Responses to DGAA Observations

Submitted by 2/24/04

OBSERVACIONES DE DGAA

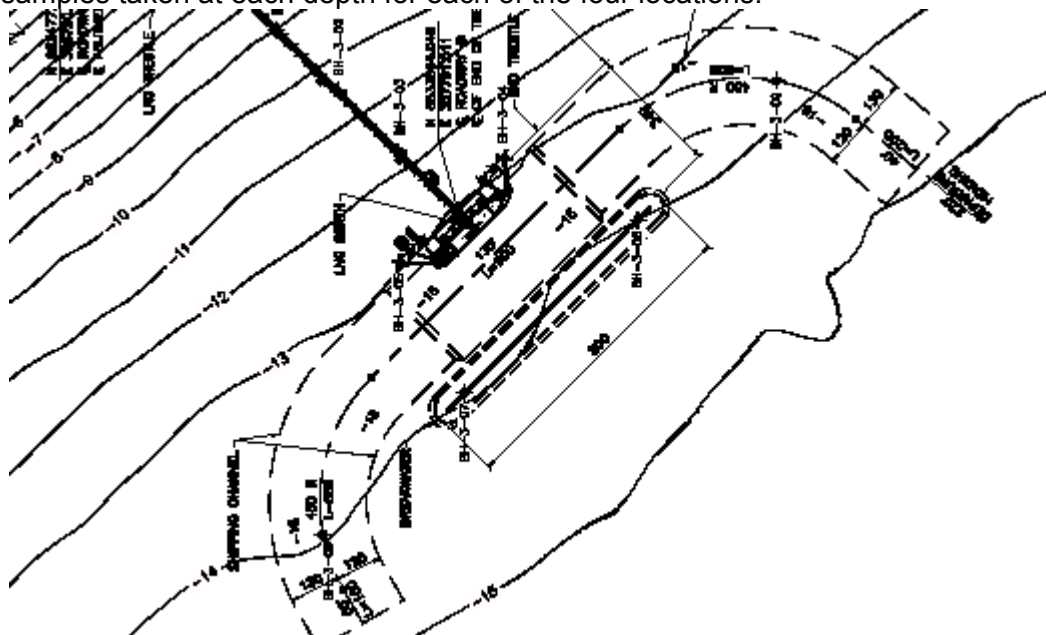
74. Submit the physical-chemical characterization of the sea bottom up to three meters corresponding to the dredging depth, in order to determine possible contaminated areas that may be removed during the dredging of the canal.

Peru LNG has conducted detailed geotechnical investigations and testing of samples in the area to be dredged. Data was taken along the 14 meters depth contour from the center of the north side channel (BH-3-06) to the center of the south side channel (BH-3-09) with two additional sample points evenly spaced in between (BH-3-07 and 08). Chemical tests were performed on five samples between the surface and 5 meters depth at each test point. The locations are shown on the plan drawing below. The table following shows the results of analysis completed at the various seabottom samples taken at each depth for each of the four locations.

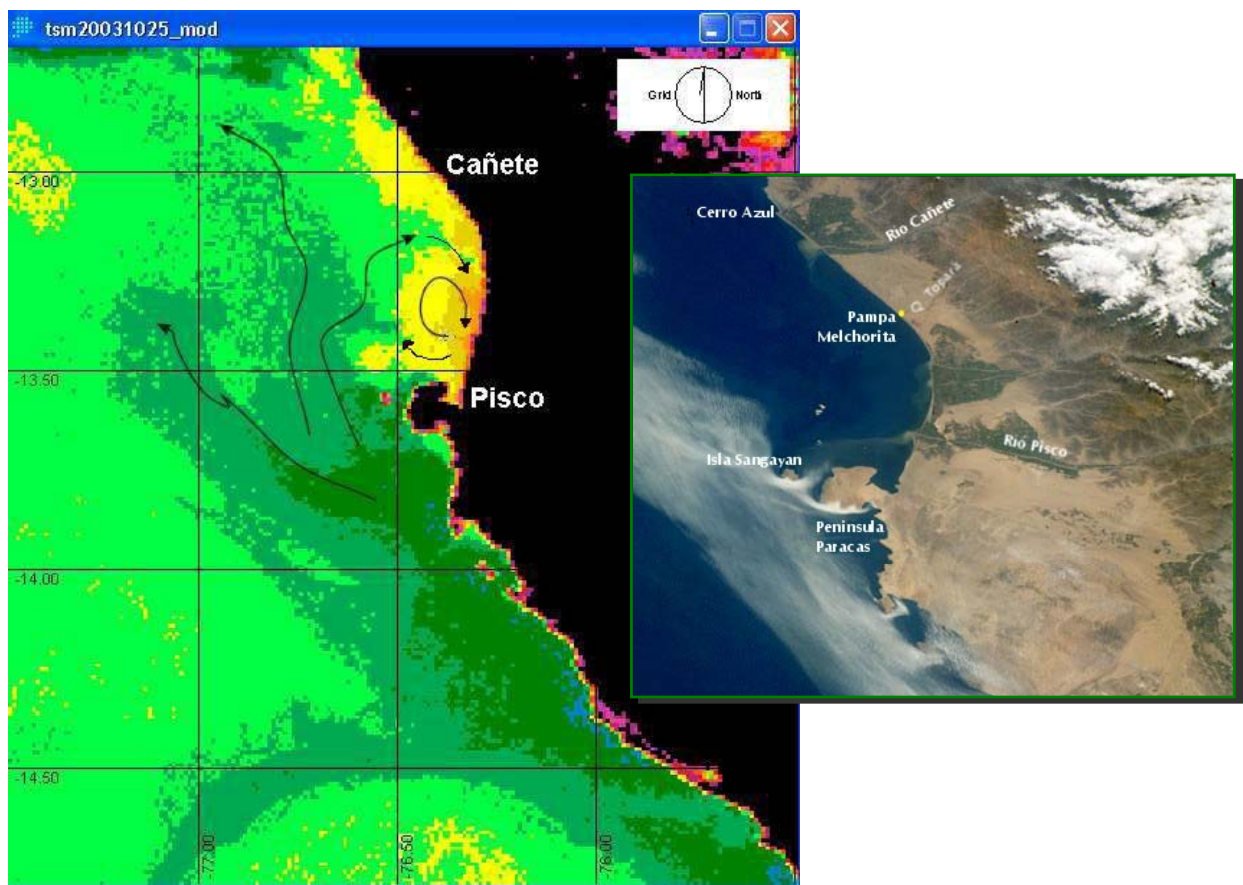
140. As the studies suggest, the area that will be affected by the direct impact of the construction and operation of the maritime terminal is the component of a coastal oceanic cell with a service area extending between the Paracas Peninsula to the south, the Centinela Point in Cerro Azul to the north, and the Chincha Islands to the southeast (including the San Gallán, Ballestas and Blanca Islands). The consistent presence of cold waters is also an indicator of the proximity of outcropping areas across from Pisco. Although in some parts of the study, the specialists refer to this oceanographic micro-area phenomenon, in the interpretations and results of the investigations, the information has not been integrated, and is only related to general oceanographic and ecological phenomena that occur all along the Peruvian coast.

An oceanic cell is defined as an area consisting of approximately 100 km by 100 km. An oceanic cell is used to conduct meso-scale oceanographic studies where all processes that occur within the cell that include the surface and water column are investigated and clearly understood. A distinct oceanic cell is identified by having a distinct water column inter-face between two oceanic layers (thermocline or pycnocline), which originate strong water mass movements within the water column. Baseline information gathered for evaluating impacts for the EIA consists of both macro (indirect area of influence) and micro (direct area of influence). This project was analyzed consistent with established EIA practices.

In evaluating the impacts related to the project, the overall movement of water mass and currents were investigated which consisted of several oceanic cells that encompass many oceanic cells which move water in a counterclockwise direction along the South American coastline from the just north of the South Pole towards the equator and across the Pacific Ocean. Based on the EIA study, the overall movement of water is regionally affected by orientation of the coastline near the project site bounded by the peninsula of Paracas and Cañete that creates a unique circulation pattern as presented in the below-referenced figure. This pattern of circulation although located within a specific oceanic cell, is predominantly influenced by local conditions. In contrast, the movement of water beyond the direct area of influence i.e., 50 km west of the shoreline is predominantly influenced by the Humboldt Current, which generally flows towards the north.
